Subject: RE: 110412 FAI 037 Safety Project D5 Requests Cost Proposal ASAP

Subject: RE: FAI-37-6.34 Preliminary Right of Way Plans (PID No. 110412)

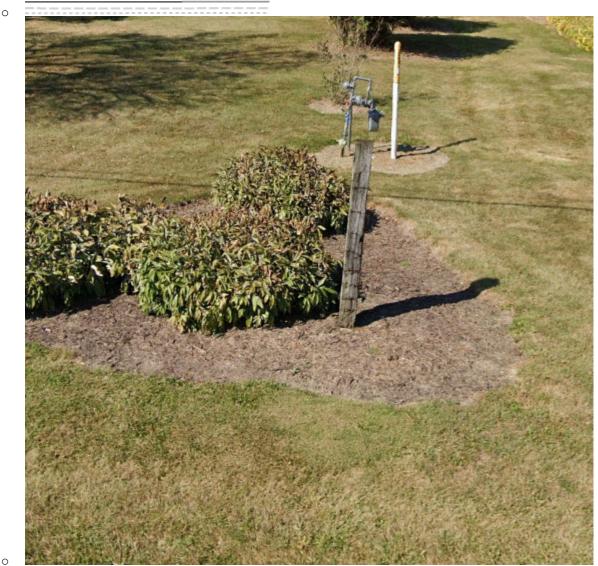
- Missing sheet 20 of 37 as Luke stated.
- Page 21/36 (22/37) Parcel 11-SH shows "Utility Pole Save" for private light poles. I would have them removed as ODOT will need to pay for them anyways (in take area) and would need to do a permit (not recommended) for the poles that are very close to the fence needing removed. Same Parcel has three of those poles (not 2) and also has a small sign near the fence that was not picked up on these plans:
